Boost-By-Pass Valve Supersession for the HP600 SCi, HP662 SCi and HP700 SCi

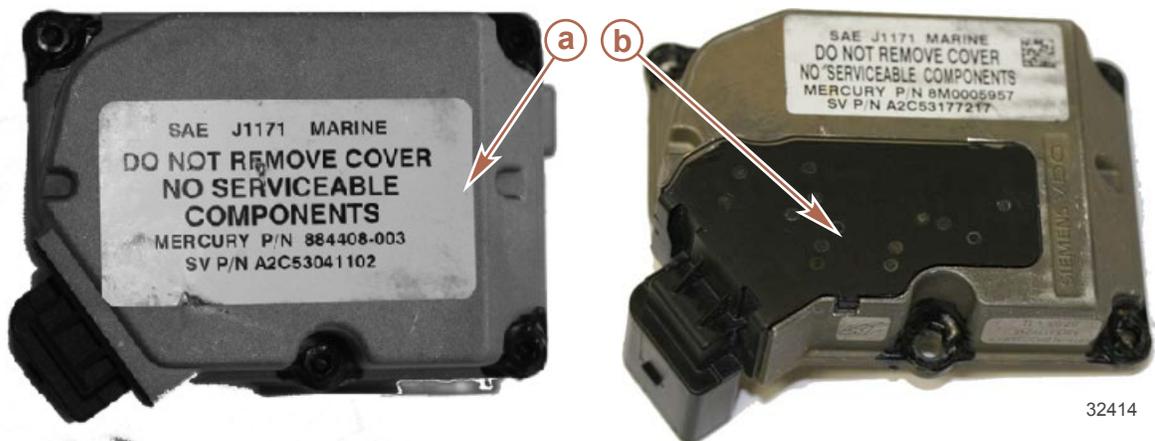
Mercury Racing developed a new calibration for the existing PCM on engines with the newer boost-by-pass valve (P/N 884408A07). Engines with the newer style boost-by-pass valve and the original calibration may experience no or low boost pressure resulting in a noticeable loss in engine performance. Engines with the older boost-by-pass valve (P/N 884408T05) can have the PCM calibrated at the owners expense.

a - Older style valve

b - Newer style valve

4. PCMs that receive this calibration update will be labeled 846123003, 8M0021279, or 8M0032385. Upon receiving the recalibrated PCM, reinstall it on the engine according to procedures in the **Service Manual**.
